# ***AIRSPACE MODERNISATION AIRSPACE CHANGE PROPOSAL***

## ***STAKEHOLDER ENGAGEMENT APPENDIX G***

### ***POST-SUBMISSION STAKEHOLDER CORRESPONDENCE***

***AIRSPACE MODERNISATION AIRSPACE CHANGE  
PROPOSAL  
(ACP-2021-056)***

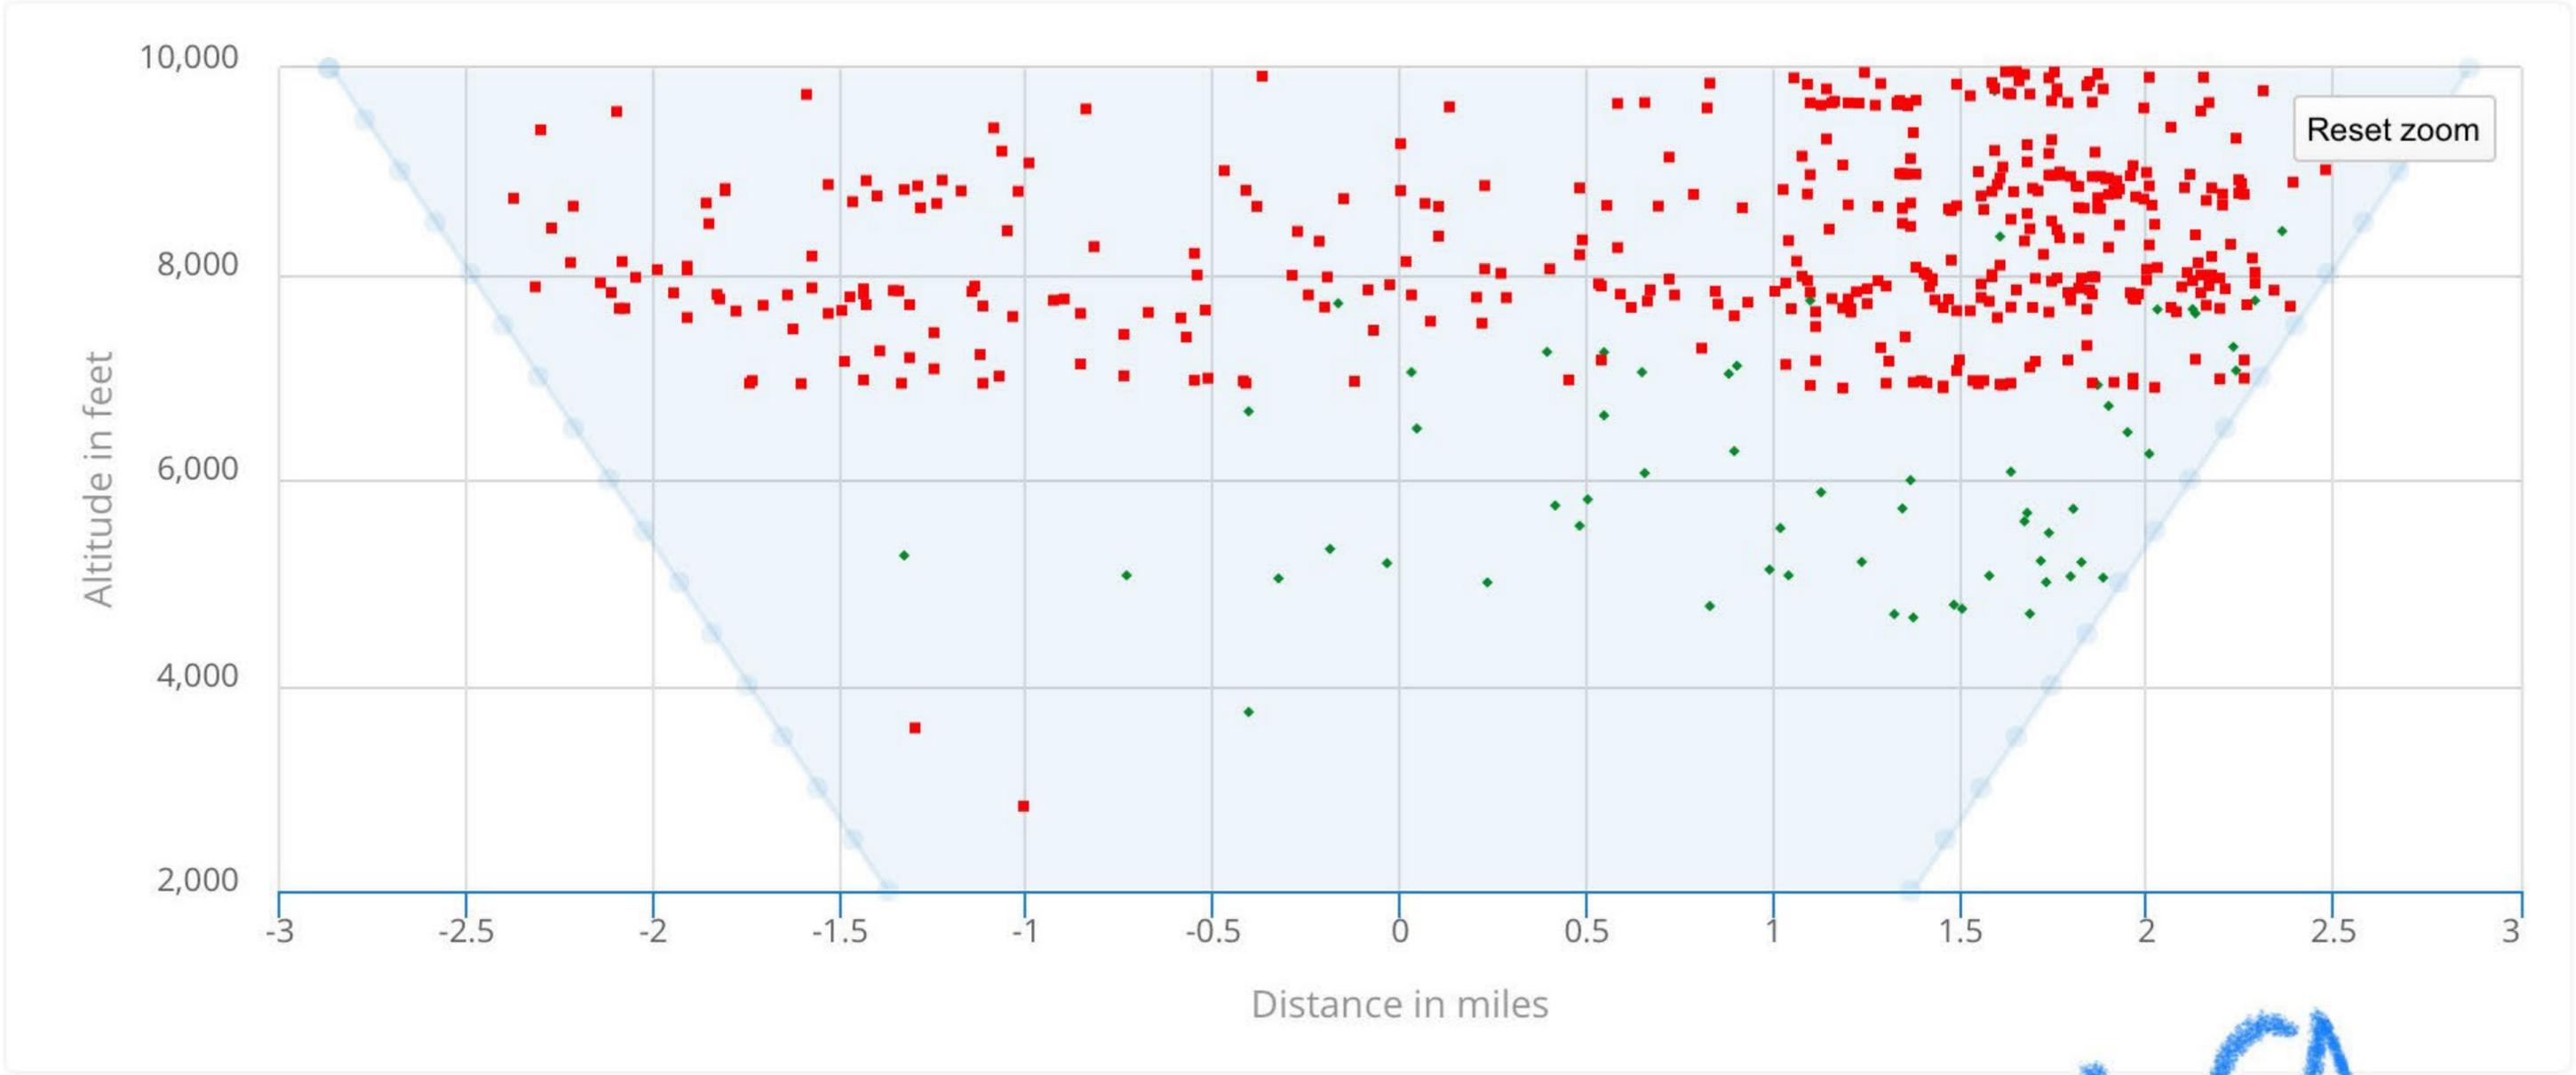
This is concerning because presently Heathrow has a skewed perspective of noise over us. Their assessment is inaccurate. This is <http://xplane.emsbk.com/xplane/> for over us in 2019 for seven days from the 14-21 August (see below). This we consider to be our benchmark. As you can see, the impact was negligible. Do these measurements reflect the data you have modelled for benchmarking over us?

Pattern of disturbance has also changed

2023 evidences flights lower flights and more concentrated flights at lower heights.

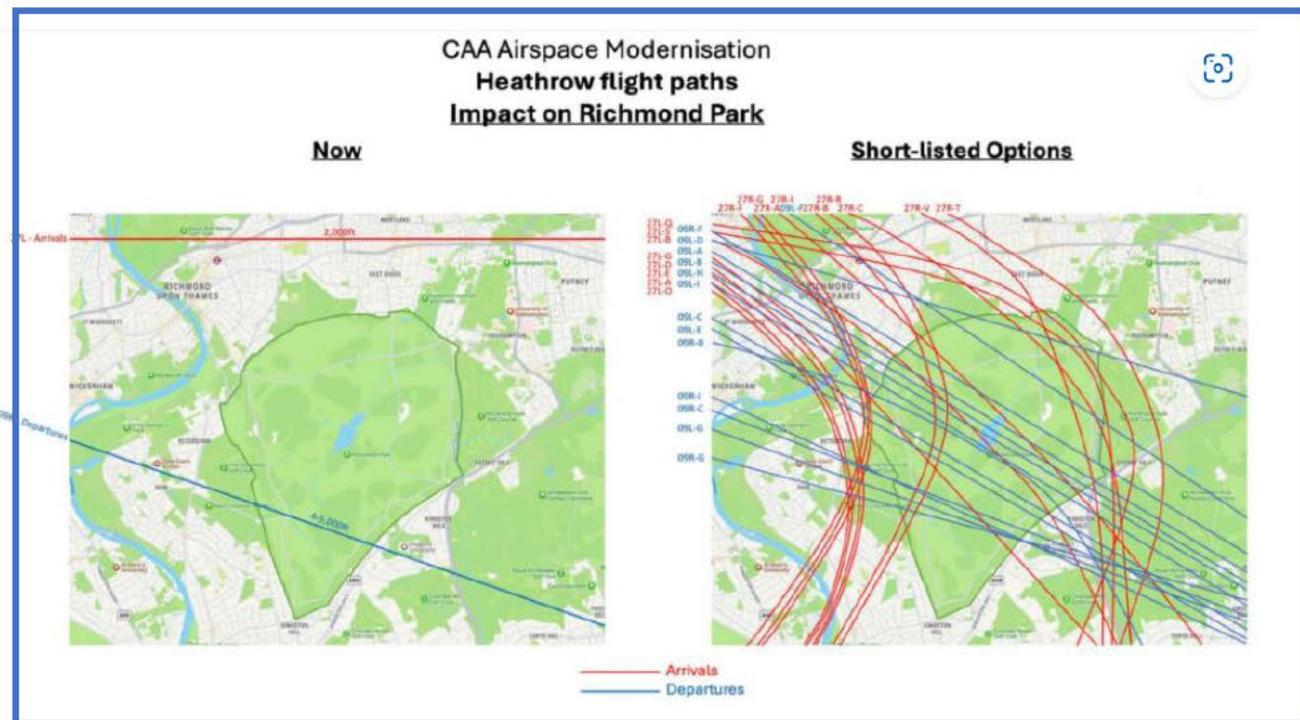
This is misleading:

- a) Heathrow is not “adding new flights” through this ACP, and
- b) None of the data has indicated “up to 60,000 new flights a year over Richmond Park”.

This is misleading: none of the data has indicated that “new flights” will be “up to 235 a day, one every 90 seconds at peak times”

Figure 1 Heathrow Airport 2019 Summer Noise Contours and Noise Action Plan Contours CAP 2001 page 69

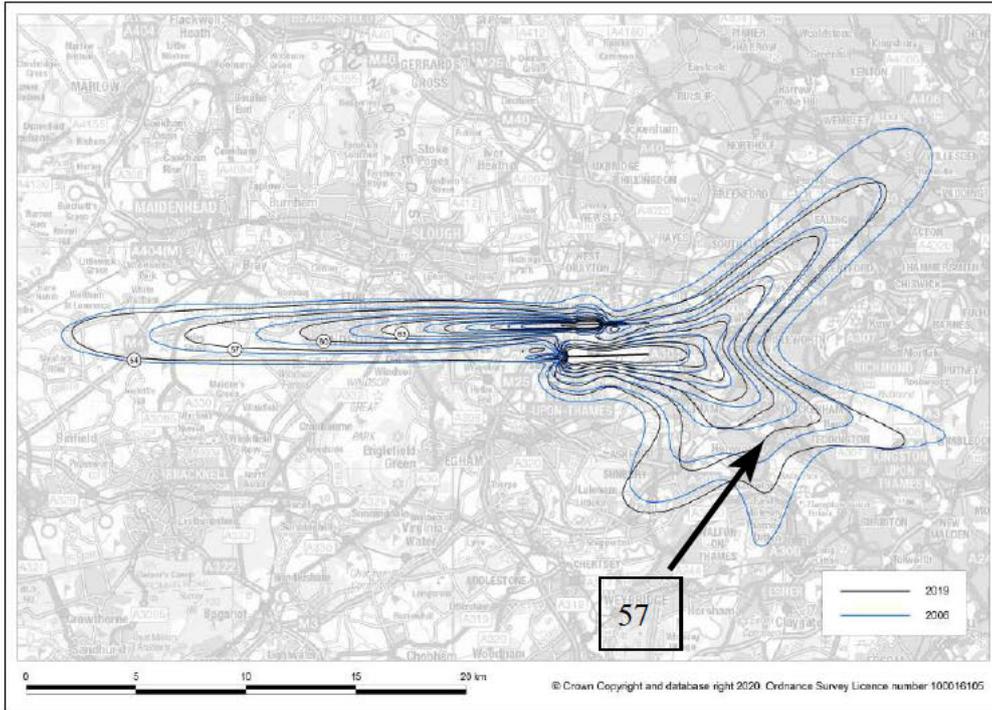
The noise contours for summer 2019 as presented in CAP 2001 for Departures on Easterlies during the Day are shown in Figure 1 over-page. The noise contour for the Base/Do Nothing case used by Heathrow in their modelling of airspace change options seemingly is intended to replicate the contours in Figure 1. And this they seem to do as shown by Figure 2 over-page, which has been taken from Appendix A13.8 page 9 on the CAA airspace Change Portal for Heathrow's airspace modernisation.

Also, on page 9 it says 'The Total population within Partial LOAEL(>51 dB LAeq,16h) 07:00 - 23:00 is 169,000. Yet in CAP 2001 it is stated on page 27 that the population exposed above 54 dB is 435,300. The population at >51 dB surely must be much greater than that at >54 dB and therefore the 169,000 in the airspace change report is seemingly substantially understated.

Of course there may be a perfectly good explanation but it would be appreciated if Heathrow could explain the seeming discrepancies in population numbers exposed and the noise contour maps.

I can confirm that our noise contours differ to those show in Figure B6 of ERCD Report 2001 because our contours show:

- a) Single direction operations (just departures in the case of Figure 2 in your note) and,
- b) Average easterly/westerly split (i.e. easterly routes only in use ~30% of the time).

Conversely, Figure B6 in the ERCD Report assumes 100% use of easterly operations (this is explained in paragraph 3.10 of the ERCD report) which would lead to a greater number of people being within the higher noise contours.

Figure 2 Heathrow Stage 2B submission to CAA July 2023 Appendix E A13.8 page 11

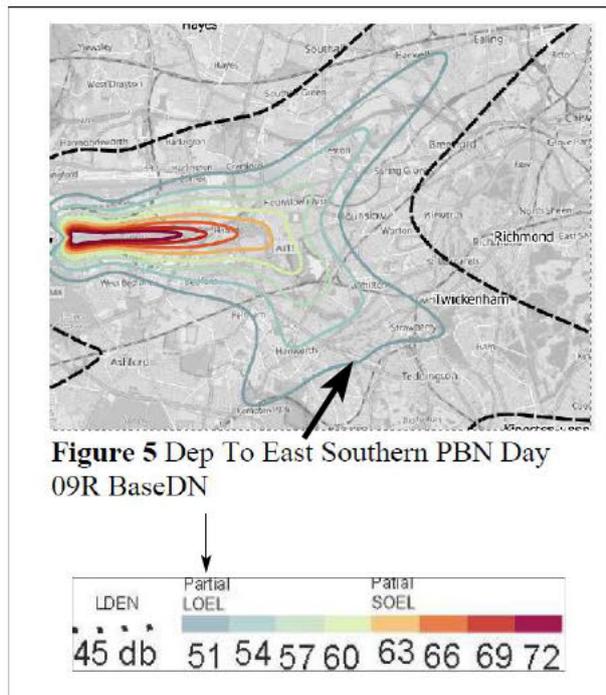
The other airspace change options have not been examined in this detail but looking at the population estimates they appear to be substantially under-estimating the number of people exposed. Also, the noise contours maps for all the options appear to have similar discrepancies.

**Figure 1** Heathrow Airport 2019 Summer Noise Contours and Noise Action Plan Contours CAP 2001 page 69

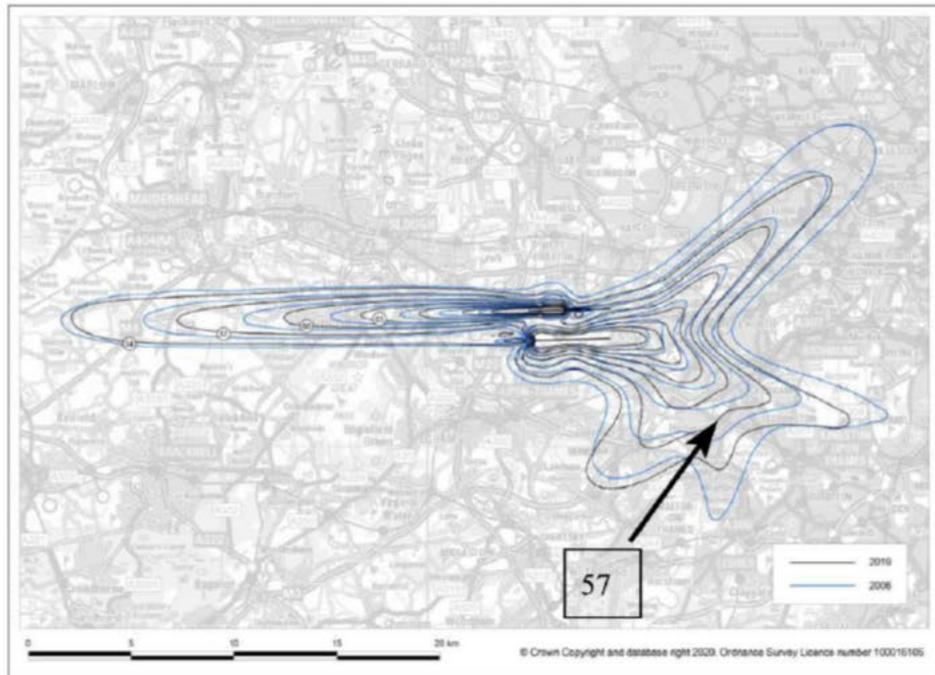
I also attach a single slide concerning airspace modernisation that we would like to cover briefly at some point tomorrow, perhaps in AOB. [REDACTED] did respond to [REDACTED] about this in an email on 14 November 2023 but we remain concerned about the apparent noise contour discrepancy.
